MLS 13-A (RTU #408) EMERGENCY GENERATOR REPLACEMENT FOR

MANATEE COUNTY, FLORIDA COUNTY PROJECT NUMBER: 6022382

ADDENDUM 1 - ATS REPLACEMENT

ELECTRICAL SITE PLAN

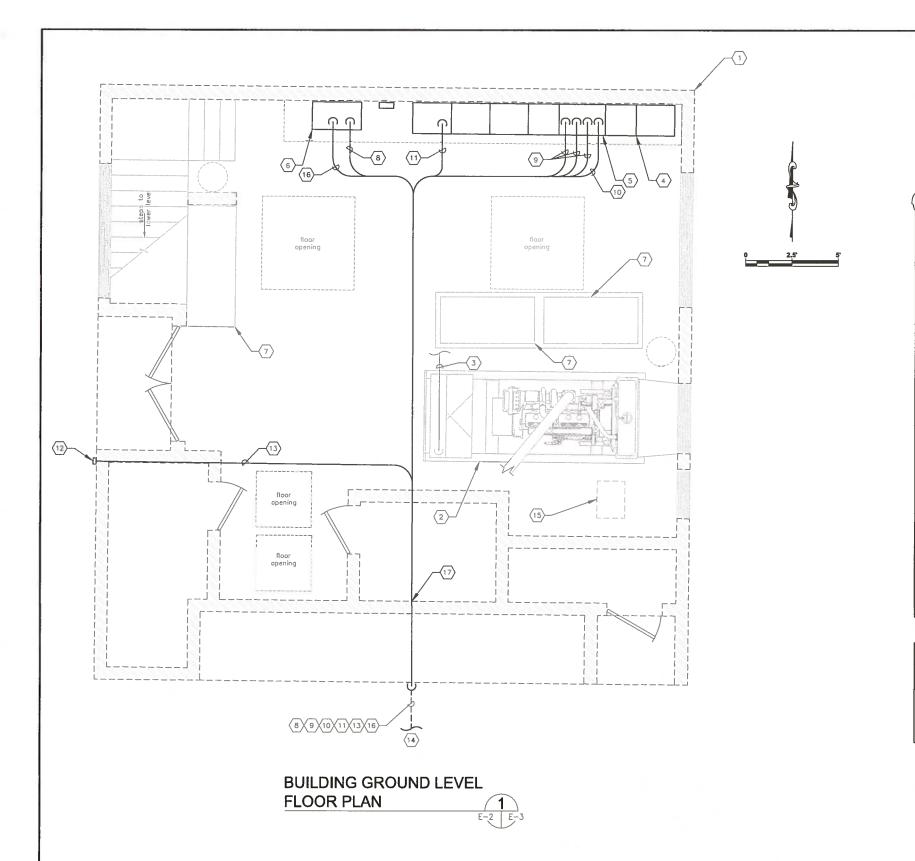
- EXISTING UTILITY TRANSFORMER, NO WORK REQUIRED. EXISTING AUTOMATIC TRANSFER SWITCH (ATS) FOR LIFT STATION 1.3A. ATS TO BE REPLACED, REFER TO SHEET
- E-5 FOR ATS ELEVATION AND WORK REQUIRED. 10 EXISTING PLC CONTROL CABINET FOR LIFT STATION 13A. REFER TO SHEET E-5 FOR PLC CONTROL CABINET ELEVATION AND WORK REQUIRED.

LIFT STATION 13A ATS REPLACEMENT **DETAILS**

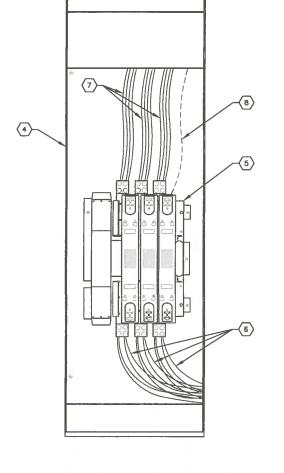
- 1) EXISTING AUTOMATIC TRANSFER SWITCH (ATS) ENCLOSURE. ENCLOSURE IS INTEGRAL TO SQUARE D MODEL 6 MOTOR CONTROL CENTER FOR LIFT STATION 13A. EXISTING ENCLOSURE FOR 1200A, 480V, 3-POLE, TRANSFER SWITCH TO

- 2) EXISTING USER INTERFACE FOR ATS CONTROL PANEL. USER INTERFACE AND CONTROL PANEL SHALL BE REPLACED. REFER ALSO TO SPECIFICATIONS.
- 3) EXISTING USER CONTROLS AND INDICATORS. USER CONTROLS AND INDICATORS SHALL BE REPLACED. REFER ALSO TO SPECIFICATIONS.

- (4) EXISTING ATS ENCLOSURE SHOWN WITH DOOR OPEN.
- (5) EXISTING 1200A, 480V, 3-POLE, TRANSFER SWITCH TO BE REPLACED.
- 6 EXISTING NORMAL POWER CONDUCTORS FROM EXISTING MAIN CIRCUIT BREAKER. CONTRACTOR SHALL REMOVE ALL EXISTING NORMAL POWER CONDUCTORS AND REPLACE WITH FOUR (4) PARALLEL RUNS CONSISTING OF 3-#350 kcmil THWN

- (7) EXISTING LOAD SIDE CONDUCTORS. LOAD SIDE CONDUCTORS CONTINUE TO MCC BUS. CONTRACTOR SHALL REMOVE ALL EXISTING LOAD SIDE CONDUCTORS AND REPLACE WITH FOUR (4) PARALLEL RUNS CONSISTING OF 3-#350 kemil THWN CU.

- (8) EXISTING EMERGENCY POWER CONDUCTORS FROM EXISTING GENERATOR (NOT ALL CONDUCTORS SHOWN FOR CLARITY. CONTRACTOR SHALL REMOVE ALL EXISTING EMERGENCY POWER CONDUCTORS AND REPLACE WITH THREE (3) PARALLEL RUNS CONSISTING OF 3-#600 kemil Thwn CU + 1-3/0 Thwn CU

- WITH THE EXCEPTION OF THE ATS ENCLOSURE AND SUPPORTS, THE ENTIRE AUTOMATIC TRANSFER SWITCH SHALL BE REPLACED. THE REPLACEMENT SHALL INCLUDE NOT ONLY THE ATS, BUT THE CONTROL PANEL (AND USER INTERFACE), USER CONTROLS AND INDICATORS, WIRING HARNESSES, ETC.
